Application No: PLM2020/0185
Meeting Date: 27 August 2020
Property Address: 16 Addison Road MANLY
Proposal: Development Application Prelodgement Meeting
Attendees for Council: Anne-Marie Young (Principal Planner)
Adam Croft (Planner)
Robert Blackall (Senior Environmental Officer)
Rafiq Islam (Principal Coastal Officer)

These notes are in response to a pre-lodgement meeting held on 27 August 2020 to discuss the construction of a new dwelling at 16 Addison Road, Manly. The notes reference preliminary plans prepared by Patterson Associates dated 30 July 2020.

Figure 1. Eastern elevation setback breach.

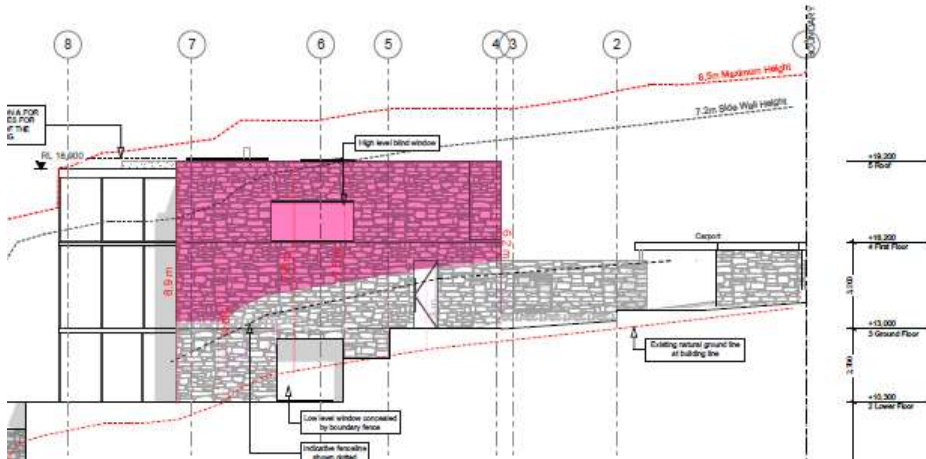
The rear portion of the dwelling that is set back 3m from the side boundaries complies with the setback control. However, the majority of the eastern and western elevations are significantly non-compliant in relation to side setback. As indicated by the shading in the below Figures 1 and 2, the majority of the first floor walls and parts of the ground floor walls are non-compliant, with limited regard given to the setback control.

Increased setbacks and articulation are required to reduce the extent of these breaches. Given that the desired built form outcome is likely to result in wall height and side setback non-compliances with limited articulation, the development should also seek to reduce the length of the side walls and the resulting presentation of bulk to the adjoining properties.

The length of the setback breach could be reduced at both the front and rear of the eastern and western walls (in the vicinity of the staircase, master ensuite, and northern void and canopy/louvres). With suitable reconfiguration of the internal floor plan, these changes are unlikely to reduce the development potential.
